Docket Nos. 50-280 ✓
and 50-281

Virginia Electric and
Power Company
ATTN: Stanley Ragone
Vice President
P. O. Box 1194
Richmond, Virginia 23209

Change No. 4
License No. DPR-32

TS Figure 3.1-1
1-17-73

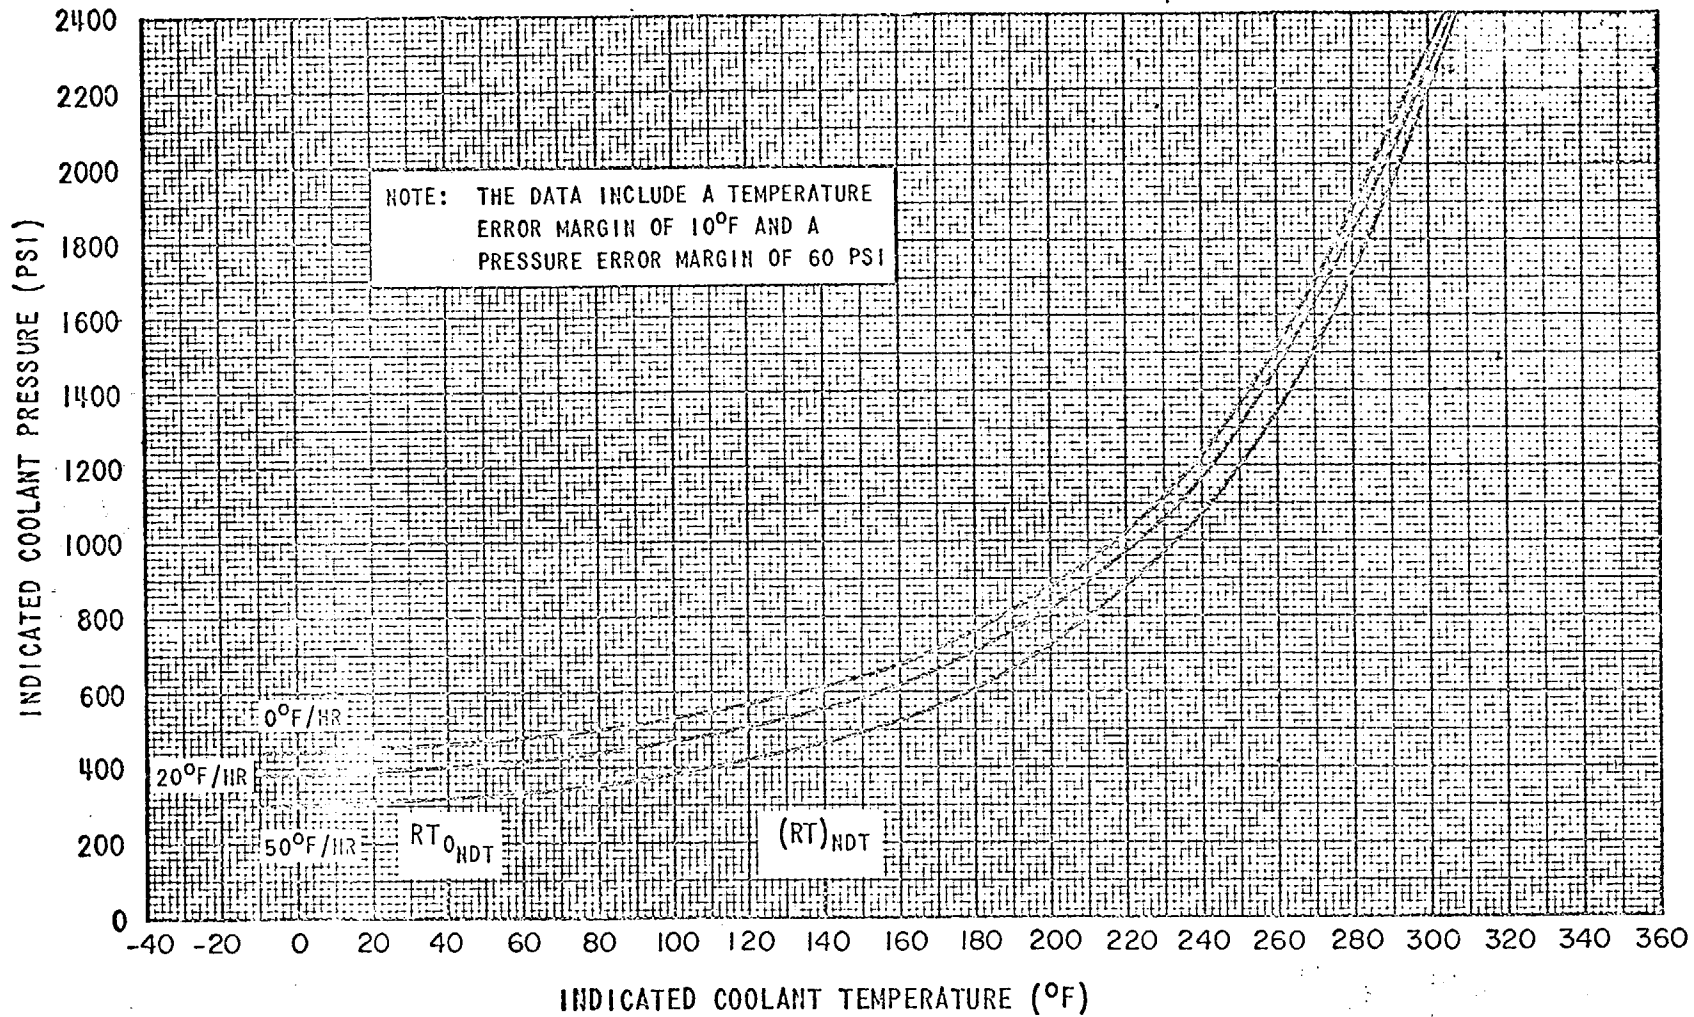
1. Change Technical Specification 3.1.B.1 page TS 3.1-6 (first paragraph) to read, "Unit 1 and Unit 2 reactor coolant temperature and pressure and the system heatup and cool-down (with the exception of the pressurizer) shall be limited in accordance with TS Figure 3.1-1".
2. Change Technical Specification Figure 3.1-1 entitled "Upper Pressurization Limits for Heatup and Cooldown - Surry Unit One" to read "Upper Pressurization Limits for Heatup and Cooldown - Surry Units No. 1 and 2".
3. Change Technical Specification 4.1 by redesignating Table 4.1-3, page TS 4.1-11, entitled "Minimum Frequencies for Flushing Sensitized Pipe" to Table 4.1-3A - Unit No. 1.

1. Unit 1 and Unit 2 reactor coolant temperature and pressure and the system heatup and cooldown (with the exception of the pressurizer) shall be limited in accordance with TS Figure 3.1-1. 4

Figure 3.1-1 Upper pressurization limit for heatup is depicted by "0°F/Hour" curve. Upper pressurization limits for cooldown are dependent as depicted, on the cooldown rates. This figure is applicable through an nvt of 1.1×10^{18} neutrons per cm^2 ($E > 1$ Mev)
